MIL-S-19500/392C
AMENDMENT 1
7 November 1994

SEMICONDUCTOR DEVICE, TRANSISTOR, PNP, SILICON, SWITCHING
TYPE 2N3485A, 2N3486A, JANTX AND JANTXV

This amendment forms a part of MIL-S-19500/392C, dated 13 August 1993, and is approved for use by all Departments and Agencies of the Department of Defense.

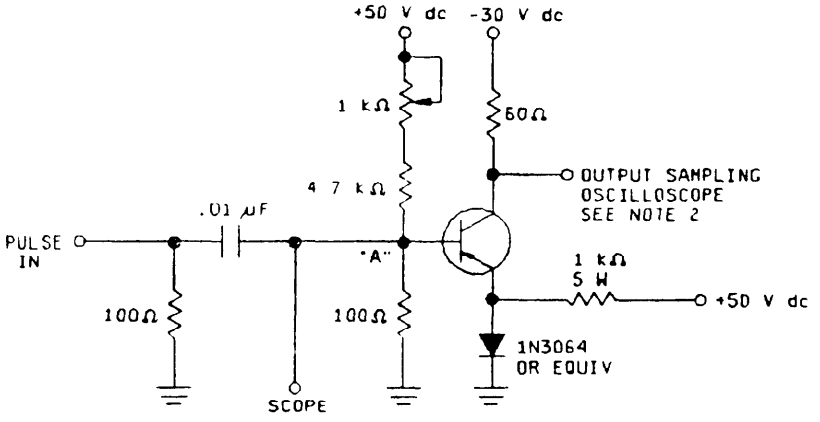
4.4.2, delete "(JANTX and JANTXV)" and substitute "(JAN, JANTX, and JANTXV)"; add the following below paragraph, before subgroup B3, as follows:

"Subgroup	Method	Condition
B1	2026	Except paragraph 4. of MIL-STD-750, item B (which includes paragraphs 4.2 and 4.2.1). NOTE: It is intended that steam aging requirement be optional for a period of six months after the date of this amendment."

FIGURE 3. Nonsaturated turn-on switching time test circuit."

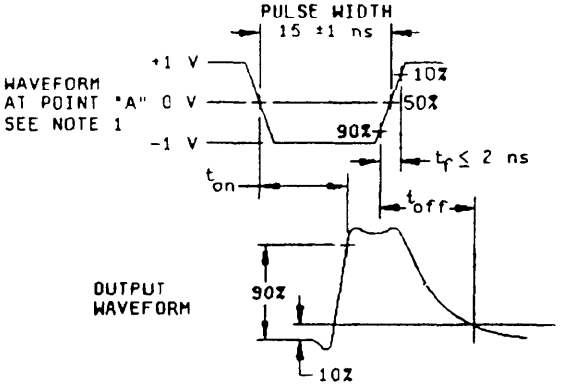
FIGUE 3, delete and substitute as printed below:

NOTES:
1. The rise time (t_r) and fall time (t_f) of the applied pulse shall be ≤ 2.0 ns; duty cycle ≤ 2 percent; generator source impedance shall be 50 ohms.
2. Output sampling oscilloscope: $Z_{in} \geq 100$ kΩ; $C_{in} \leq$ RPF; rise time ≤ 0.2 ns.
